Access Compliance Report Public Rights-of-Way (Curb Ramps)

Intersection ID: 7997 Main Street: ROZZELLES_FERRY_RD Cross Street: JOHN_MCCARROLL_AV Location: SE

ADA ID: 6E79CC5853C9 Ramp Type: Perp Initial Pass/Fail: Fail Overall Compliance: No Severity Score: 12.5

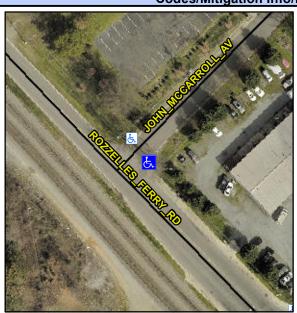
Field Measurements/Component Compliance					
Compliance Description		Data	Compliance Description		Data
N/A	Ramp Length (in)	60.0	No	Ramp Slope (%)	9.3
Yes	Ramp Width (in)	48.0	Yes	Ramp XSlope (%)	0.5
N/A	Flare Type LT	N/A	N/A	Flare Type RT	N/A
N/A	Flare Slope LT (%)	N/A	N/A	Flare Slope RT (%)	N/A
N/A	Flare Traversable LT?	N/A	N/A	Flare Traversable RT?	N/A
N/A	Landing Length (in)	N/A	N/A	DWS Provided?	N/A
N/A	Landing Width (in)	N/A	N/A	DWS Contrast?	N/A
N/A	Landing Slope (%)	N/A	N/A	DWS Length (in)	N/A
N/A	Landing X Slope (%)	N/A	N/A	DWS Full Width?	N/A
N/A	Landing Curb? (Y/N)	N/A	N/A	DWS Offset (in)	N/A
N/A	Shared Landing?	N/A			
N/A	Gutter Ponding?	N/A	N/A	Gutter Slope (%)	N/A
N/A	Gutter Lip Ht (in)	N/A	N/A	Gutter X Slope (%)	N/A
N/A	Painted X Walk1?	No	N/A	Painted X Walk2?	N/A
	X Walk 1 Direction	To NW		X Walk 2 Direction	N/A
N/A	X Walk 1 Width (in)	N/A	N/A	X Walk 2 Width (in)	N/A
	X Walk 1 Slope (%)	5.4		X Walk 2 Slope (%)	N/A

Total Cost: \$ 1850.00
